UNITED STATES PATENT AND TRADEMARK OFFICE

APPLICATION NO.	FILING DATE	FIRST NAMED INVENTOR	ATTORNEY DOCKET NO.	CONFIRMATION NO.
10/551,680	09/29/2005	Keigo Nagao	930055-2036	5620

Office Action Summary	Application No. 10/551,680	Applicant(s) NAGAO ET AL.	
	Examiner Derek J. Rosenau	Art Unit 2834

DETAILED ACTION

Figure A

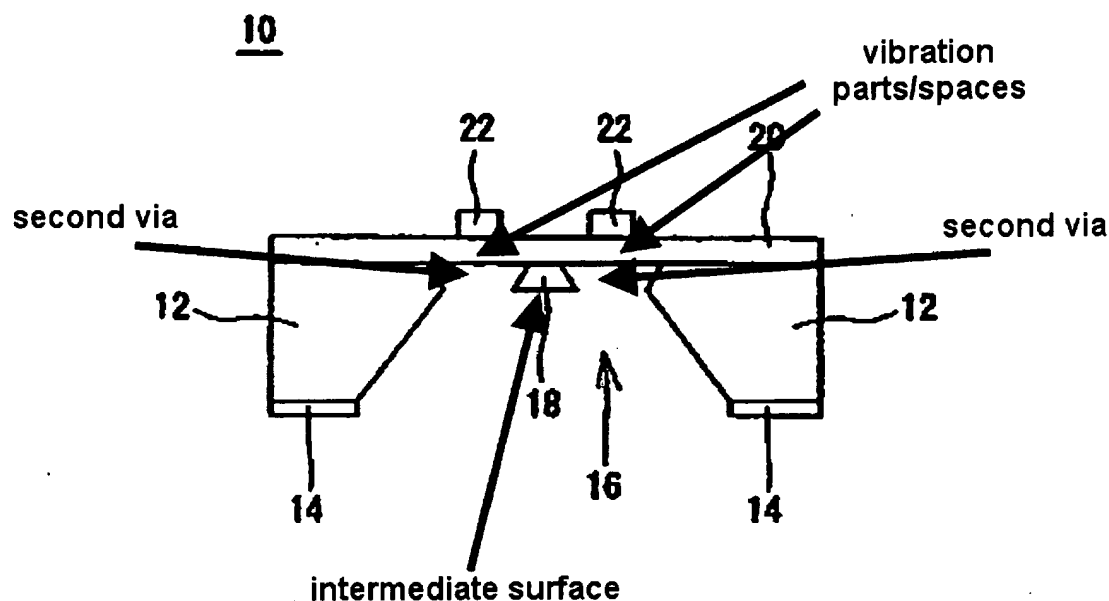
5. With respect to claim 1, Masaki et al. discloses a piezoelectric thin film device (Fig 2) comprising a substrate (item 12) having a vibration space (see Figure A below), and a piezoelectric laminated structure (item 22) formed on an upper surface side of the substrate, the piezoelectric laminated structure including a piezoelectric film and electrodes formed respectively on both surfaces of the piezoelectric film (Paragraph 2), and the vibration space being formed so as to allow a vibration part to vibrate (Paragraph 8), the vibration part including at least a part of the piezoelectric laminated structure (Fig 2), wherein the vibration space is constituted by a first via hole (item 16) formed from a lower surface of the substrate toward an upper surface thereof with an intermediate surface (see Figure A below) formed at an intermediate position in the substrate, and a second via hole (see Figure A below) formed from the intermediate surface toward the upper surface of the substrate, the second via hole being positioned inside the first via hole when viewed in a vertical direction (see Figure A below).

6. With respect to claim 2, Masaki et al. discloses the piezoelectric thin film device as claimed in claim 1, wherein plural vibration parts each being the vibration part are formed on the upper surface side of the substrate (Fig 2), the first via hole is formed so as to share a part of each of vibration spaces respectively for the plural vibration parts (Fig 2), and plural second via holes each being the second via hole are formed from the intermediate surface (see Figure A above), so as to correspond respectively the plural vibration parts (see Figure A above).

8. With respect to claim 5, Masaki et al. discloses a method for manufacturing a piezoelectric thin film device (Fig 2) of claim 1, wherein when the vibration space in the substrate is formed, a first via hole is formed from a lower surface of a substrate toward an upper surface thereof (Fig 3K), so as to form a bottom surface of the first via hole at an intermediate position in the substrate (Fig 3K), a second via hole is thereafter formed from the bottom surface toward the upper surface of the substrate material (Figure 3L), to be positioned inside the first via hole when viewed in a vertical direction (Fig 3L or Fig 2), and the intermediate surface is formed by such a part of the bottom surface that remains in the substrate material (see Figure A above).

9. With respect to claim 6, Masaki et al. discloses the method as claimed in claim 5, wherein the piezoelectric thin film device has plural vibration parts each being the vibration part (see Figure A above), on the upper surface side of the substrate (see Figure A above), the first via hole is formed to be shared by the plural vibration parts (See Figure A above), plural second via holes being the second via hole are formed from the bottom surface, so as to correspond respectively to the plural vibration parts (see Figure A above).

surface of the substrate and the piezoelectric laminated structure (Fig 2), the vibration part includes a part of the insulating layer (See Figure A above). Masaki et al. does not disclose expressly that the insulating layer has a thickness of .3 μm to .5 μm . However, it has long been held that the mere change in size of a device is obvious. Therefore, at the time of invention, it would have been obvious to a person of ordinary skill in the art to change the thickness of the insulating layer such that it between .3 μm and .5 μm .
